Steven M. Clouse WRC Electrical System Improvements Phase 2A
Solicitation Number: CO-00443
Job No.: 21-6507

ADDENDUM 3
August 23, 2021

10E05
161 OF 328

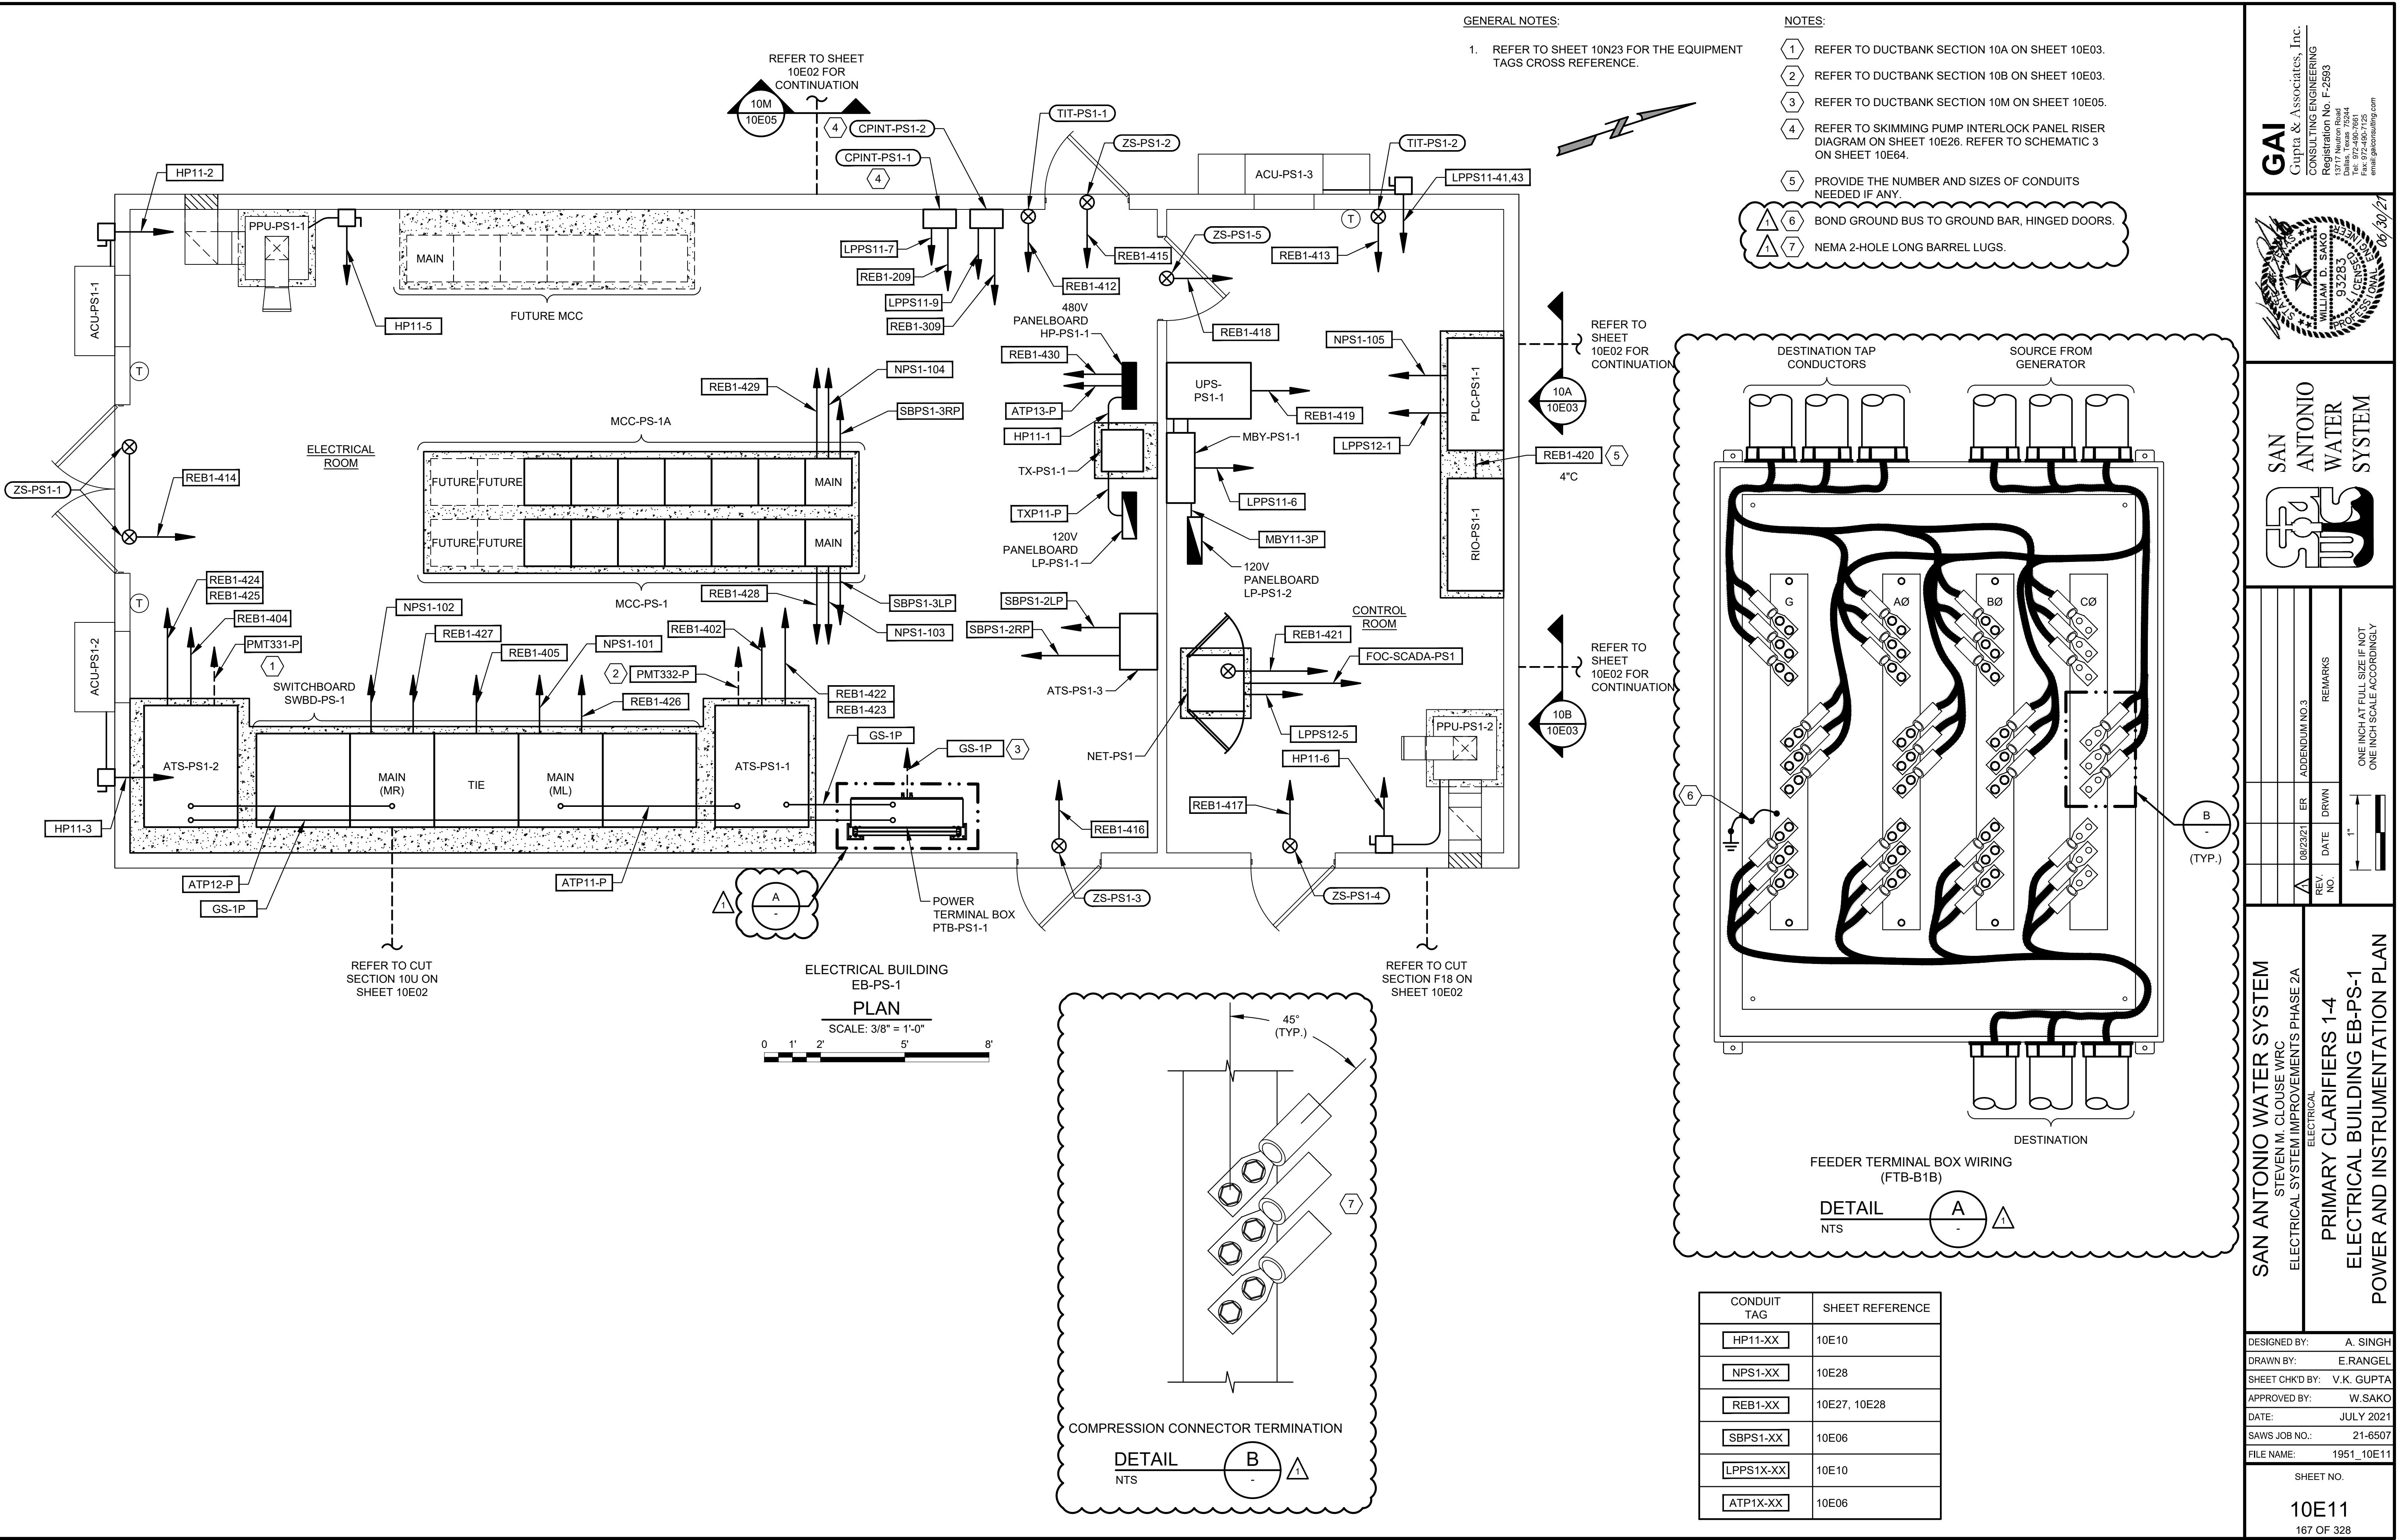
2. Sheet 10E05 ductbank section 10M Conduit # 30, circuits GS-1C1 & GS-1C2 goes to ATS-PS1-1 and ATS-PS1-2 located in separate parts of the electrical building but are routed in the same conduit from the manhole. Please review and advise. Similarly, conduit #5 contains circuits to LP-PS11 and LP-PS12. Please review and advise as this would increase the number of conduits in the ductbank from manhole LMH-14. Same situations occur in DB Section AQ on 10E33.

Response: These circuits are in the same conduit in the ductbank. Tee fittings or pullboxes can be used for exposed conduit inside the building as required for routing of circuits to different equipment. No additional conduits needed in ductbank. Refer to specification 16000.3.01.D.

10E40
196 OF 328

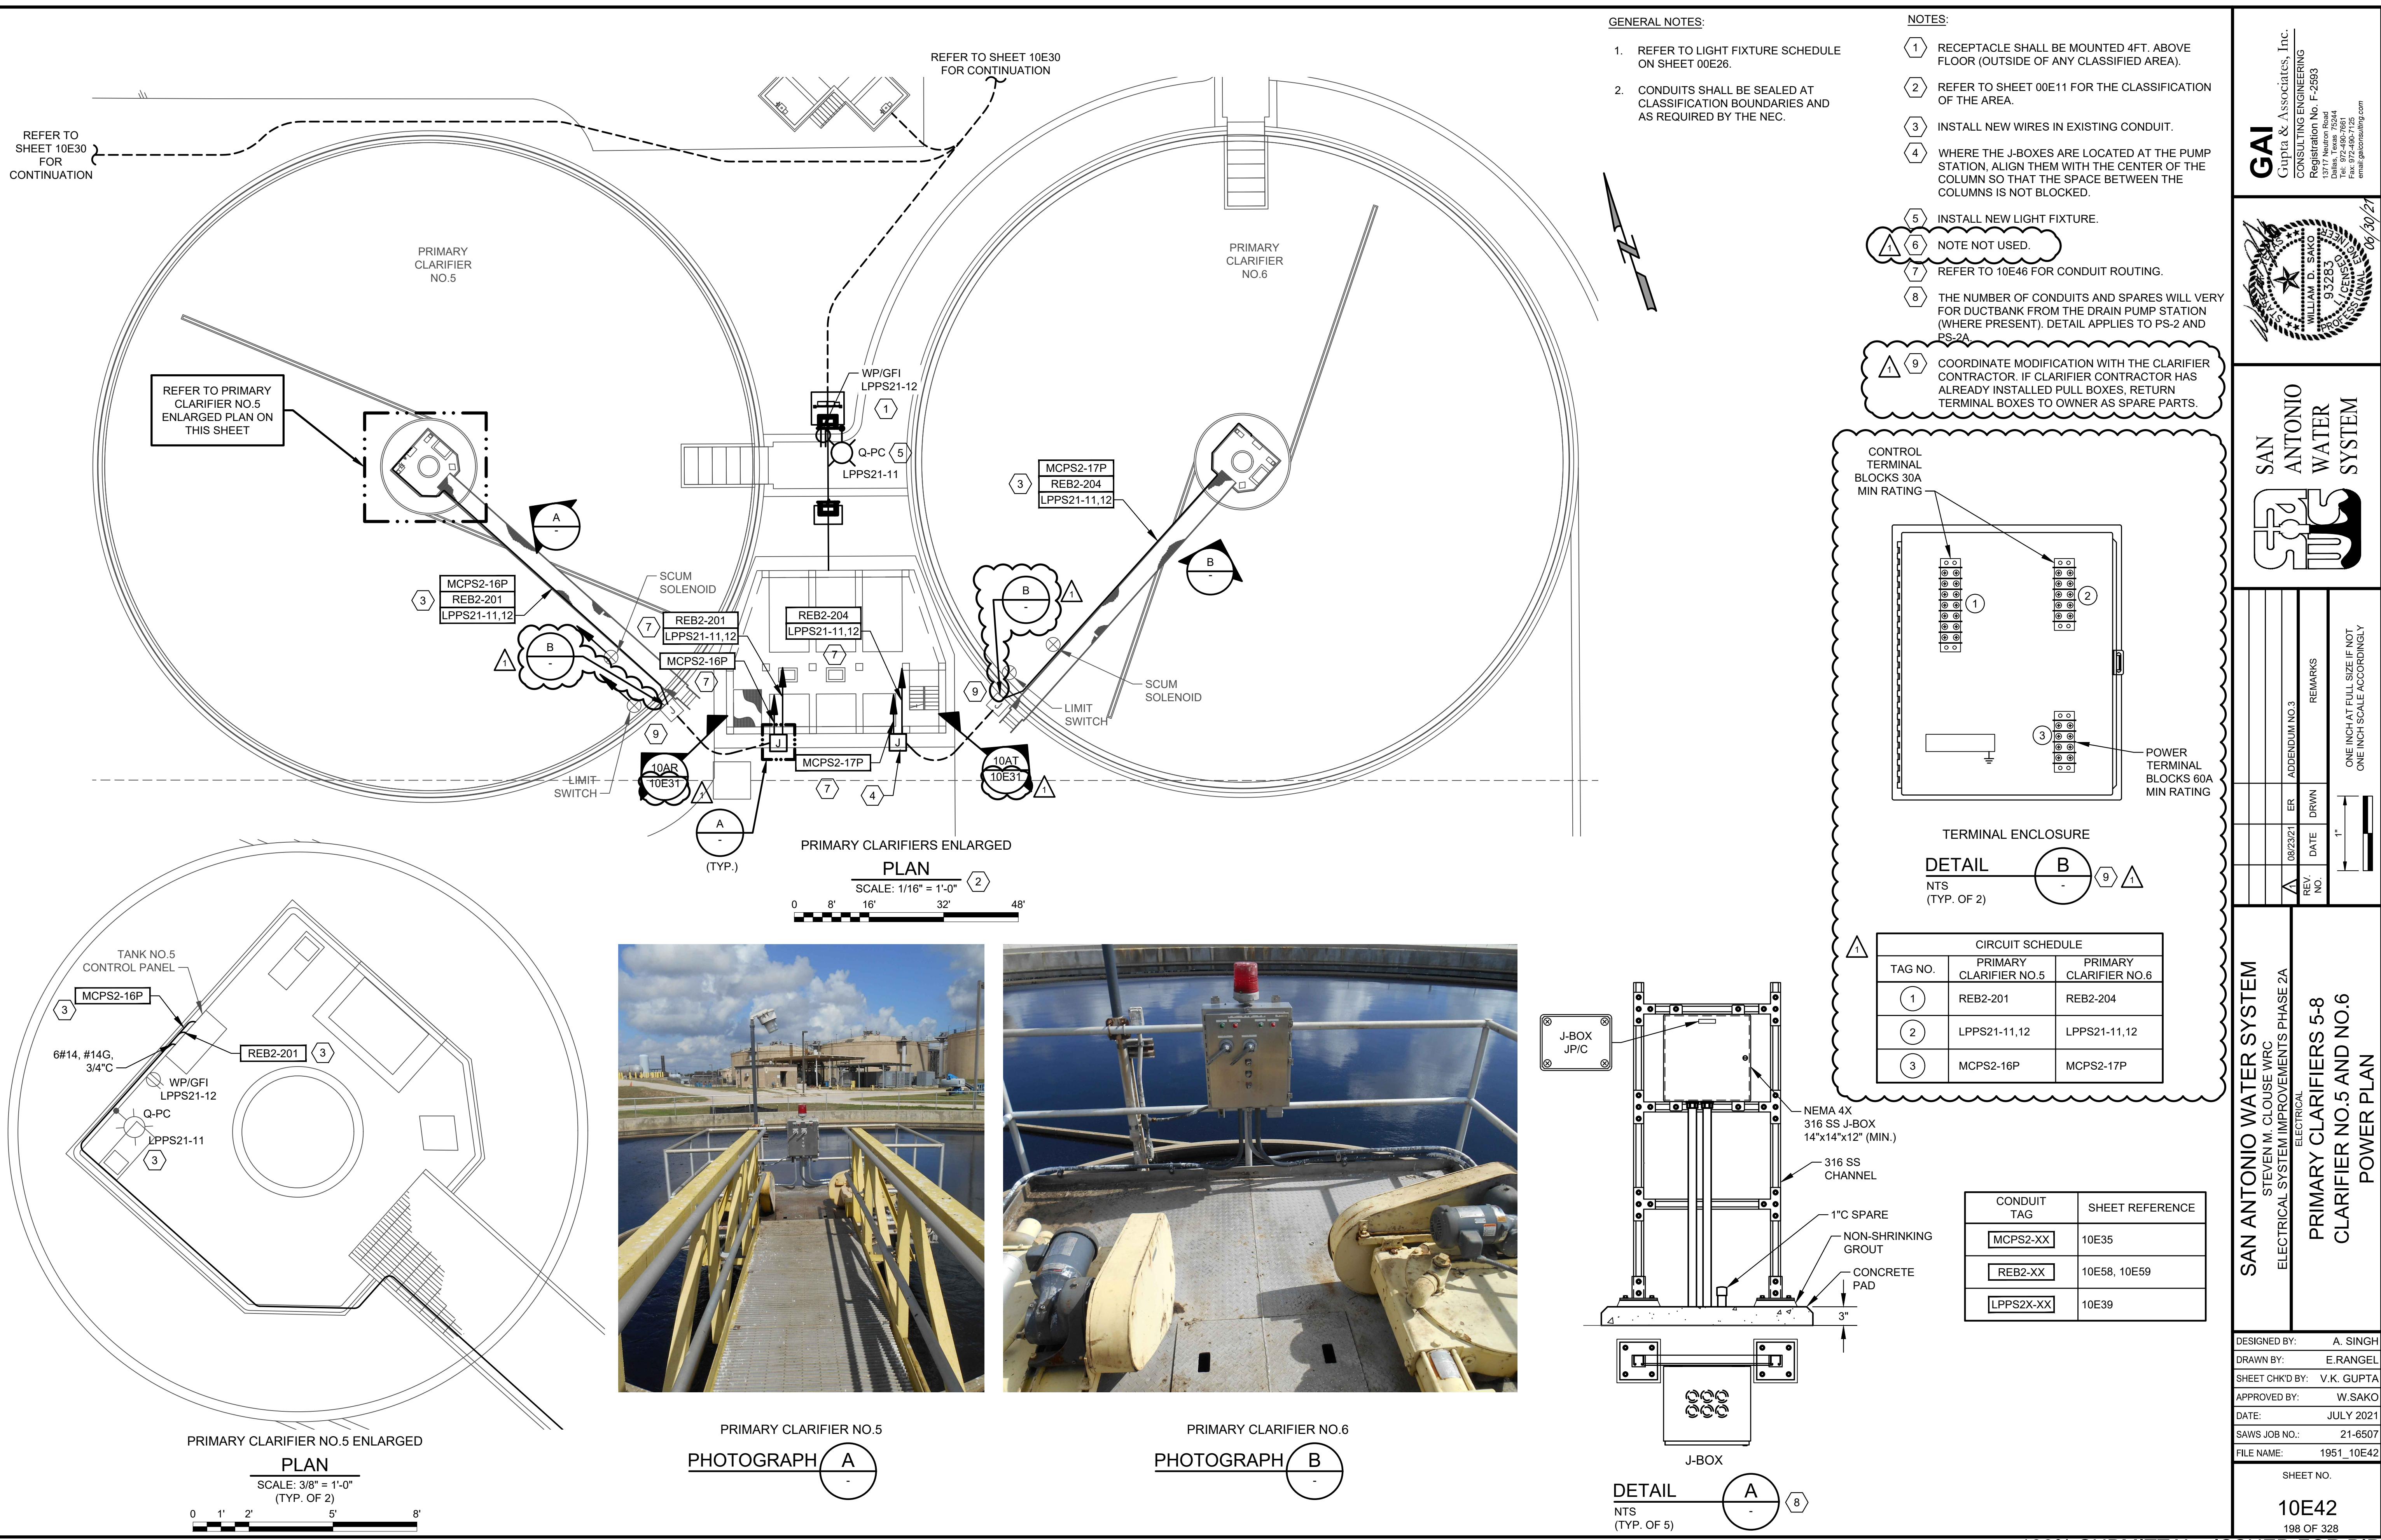
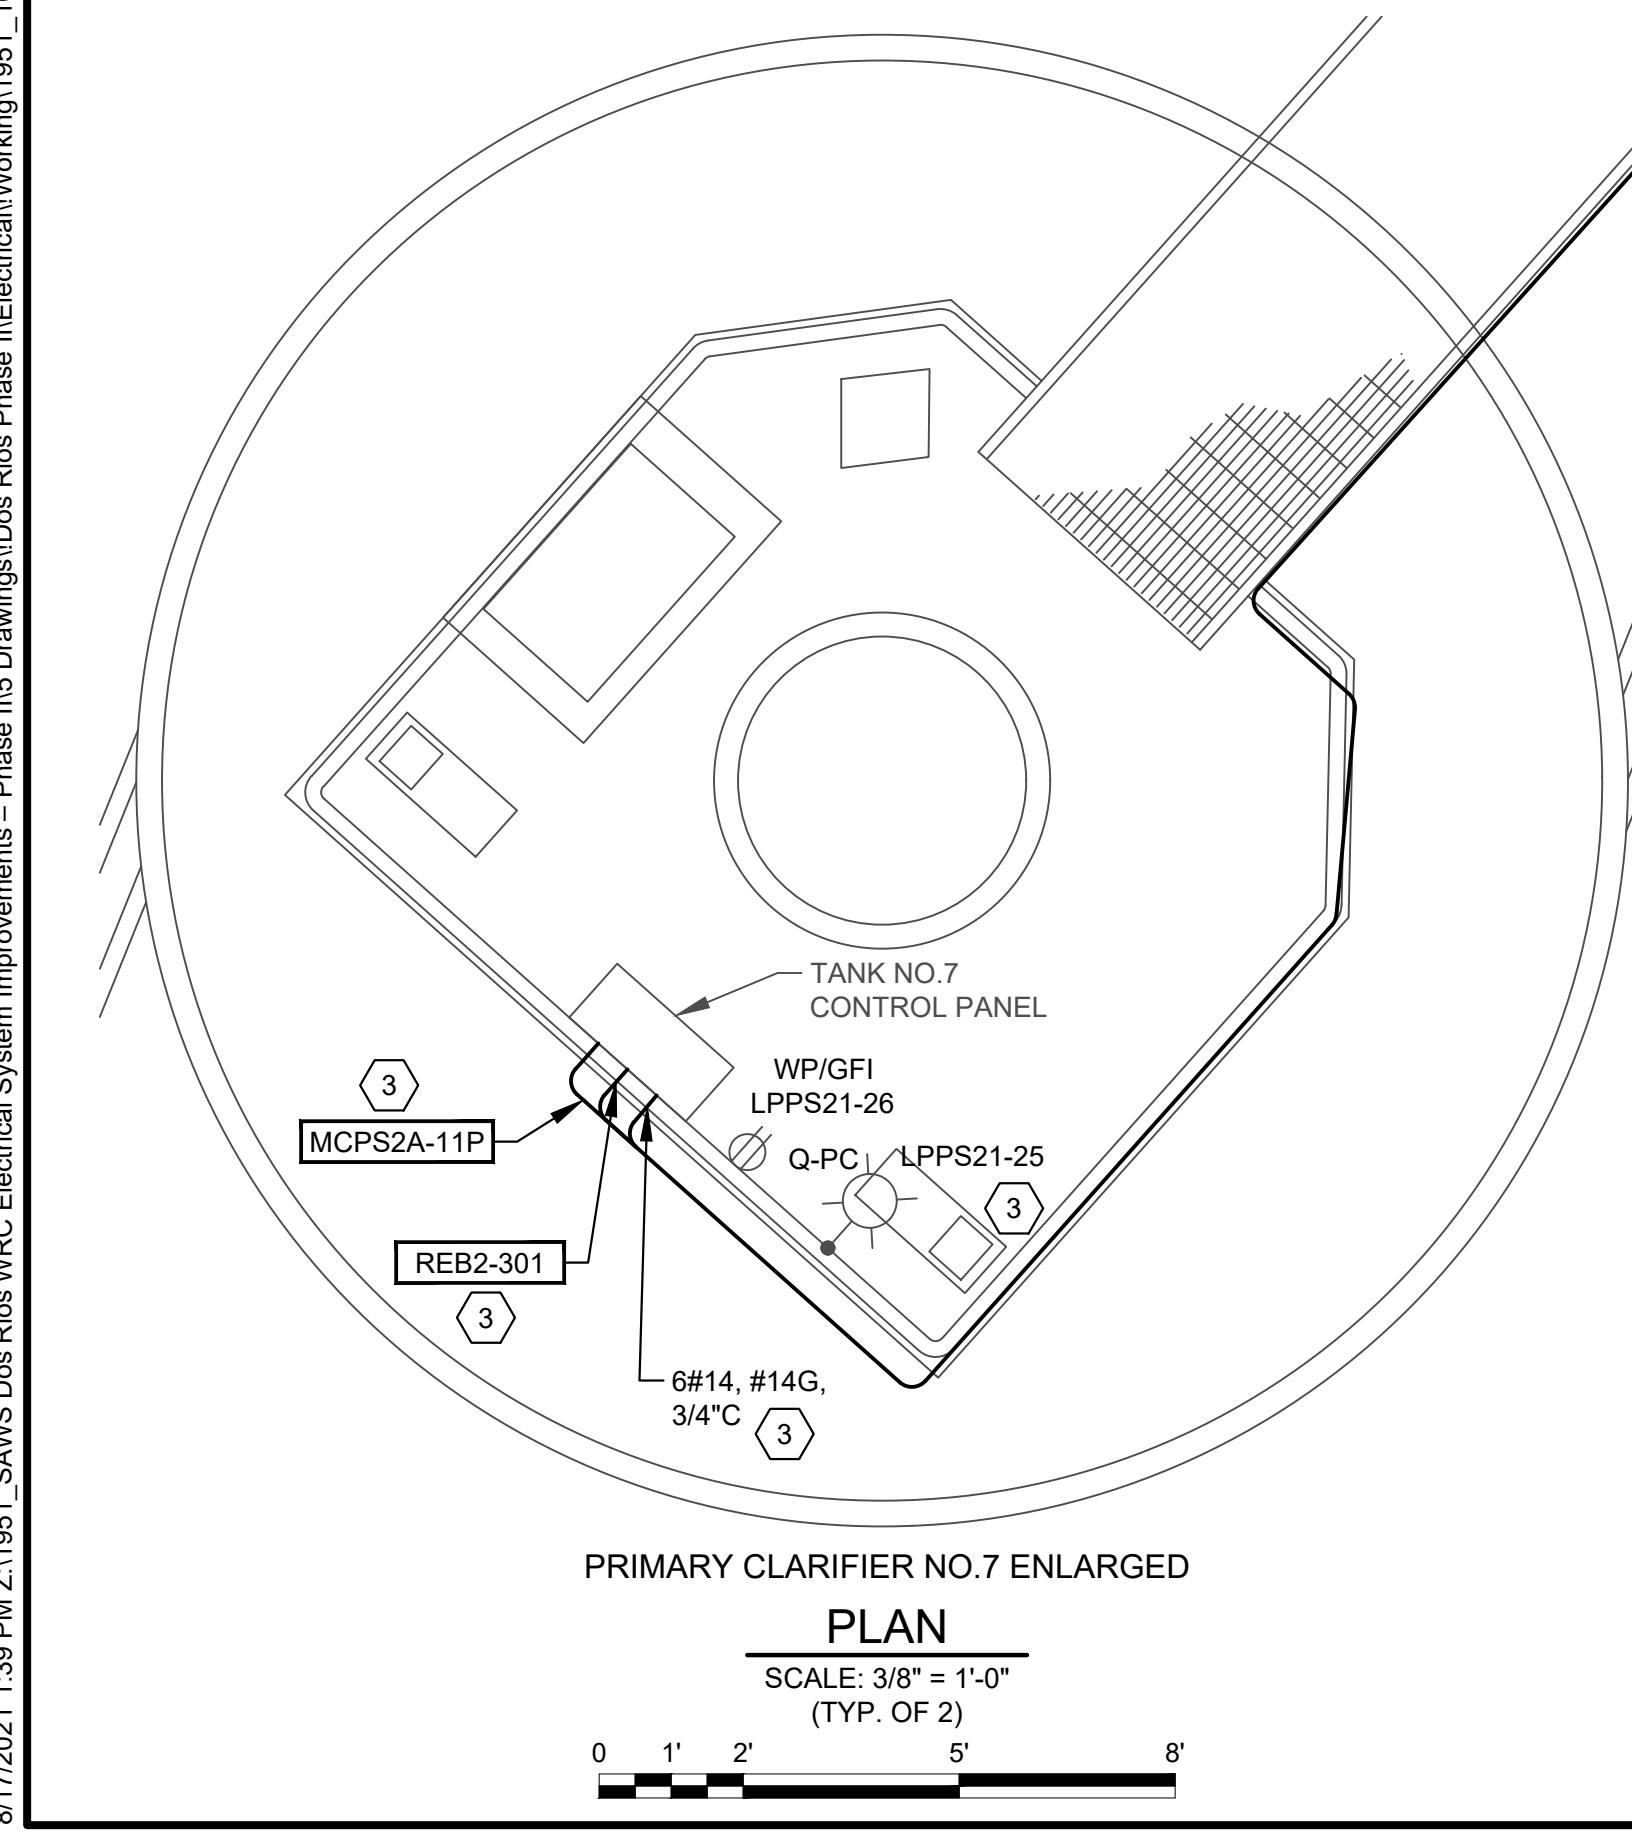
10. Sheet 10E11 & 10E40 refers to Section D on Sheet 20E71 for Power Terminal Boxes PTB-PS2-1 & PTB-PS1-1. Please provide the detail sheet..

Response: Detail added to sheet 10E11. Refer to Changes to the Plans, items “d. 10E11” and “k. 10E40”
